Sunlit squares part 2

Shadowing in Curtin Square

Revised draft master plan

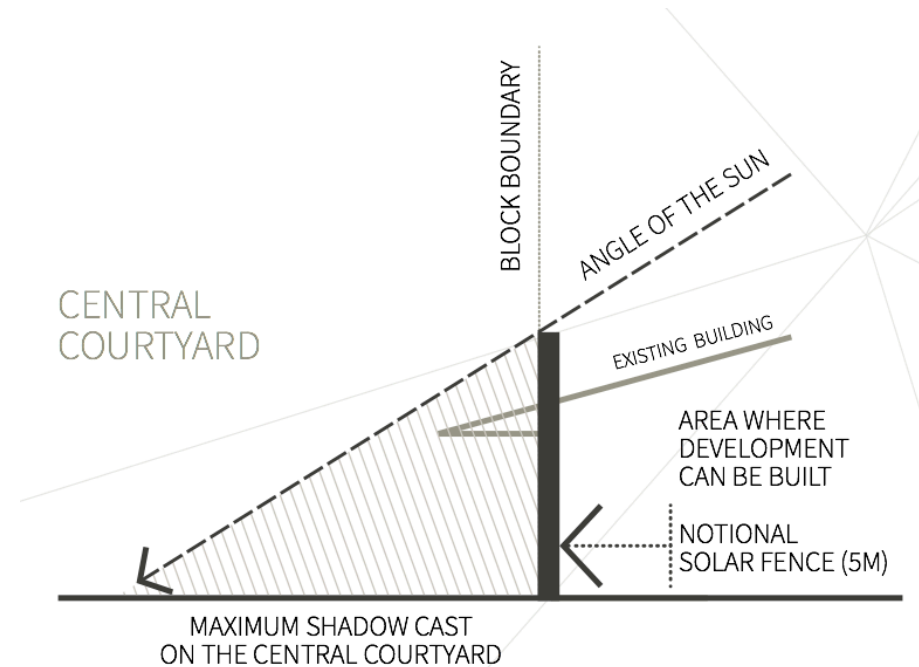
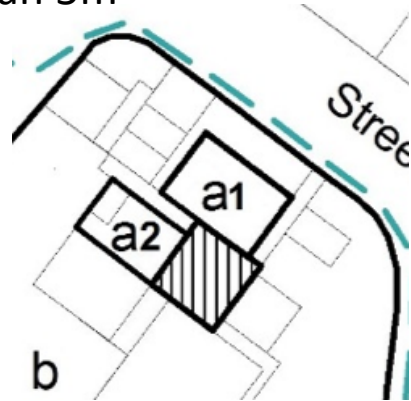
How important is sunlight
(no shadowing) in the
morning?

Shadowing in Curtin Square

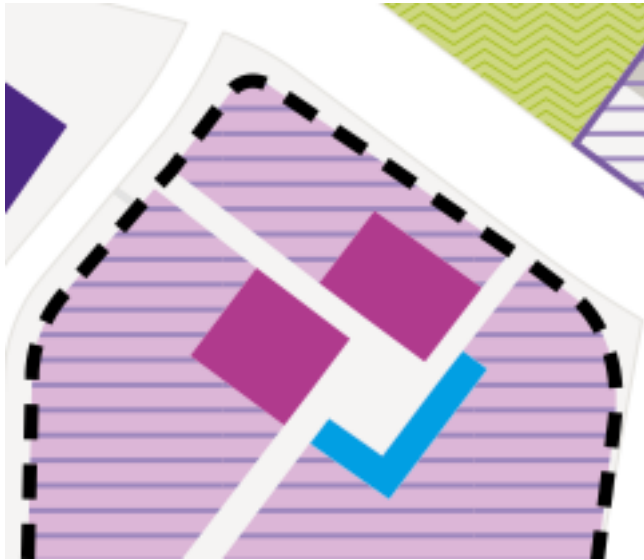
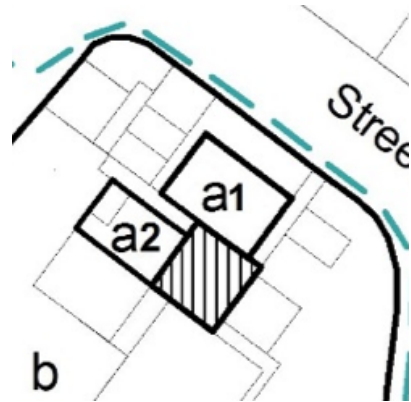
Increased shadowing of Curtin square.

Cannot evaluate the extent of the increase without modelling.

Perhaps little protection against shadowing in the morning. Again, cannot know without modelling.

Should the Residents' Association ask for modelling results to be made available to the community?
Well before the close of the consultation period? (by Friday 18 May?)
